From: Deborah Lynn
Sent: 12 February 2026 13:38
To: Buchan Rum Architects
Subject: Planning application DM/25/3185 - Chetwode, Tylers Green, Cuckfield

I write with regards to the above planning application for a “single storey front extension and new porch.”

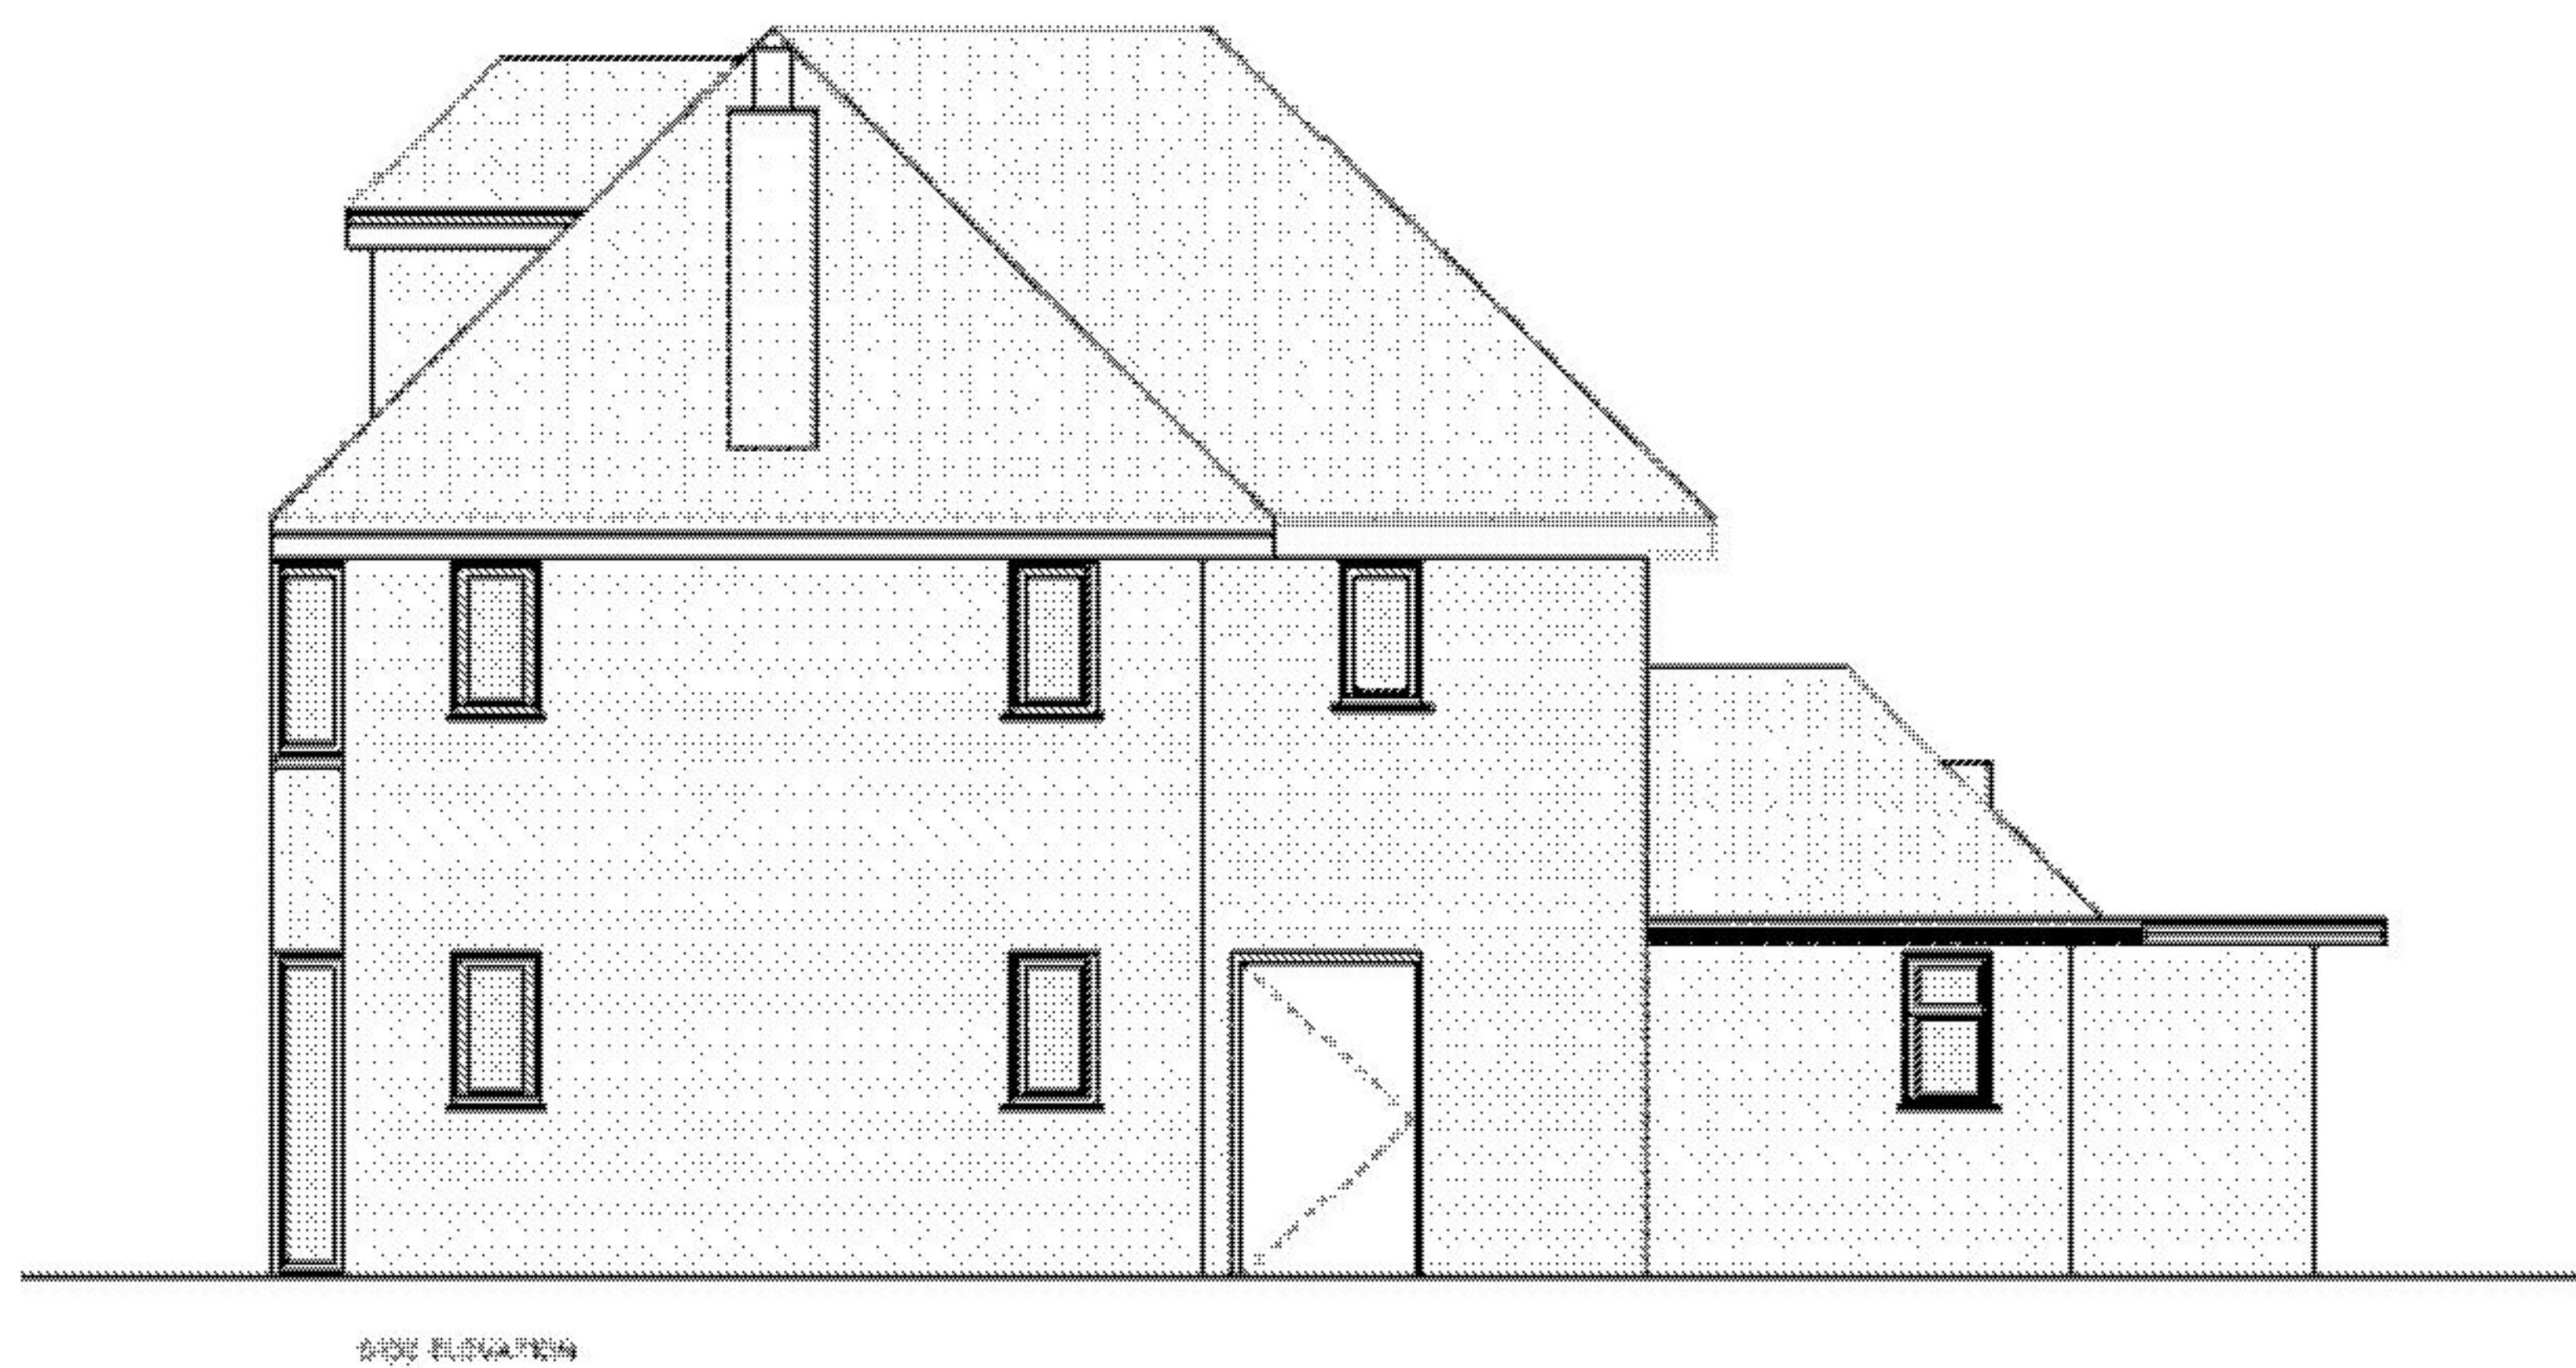
- Location and block plans:
The detached garage to the front of the property is missing from the plans, this should be shown. In addition, the proposed plans only show the 2 storey extension proposed; the single front extension and porch should be included.
- Existing floor plans:
Please can these be labelled to show how the rooms are used. The floor plans do not show the entrance porch / canopy to the front of the house, as shown in the photo below:
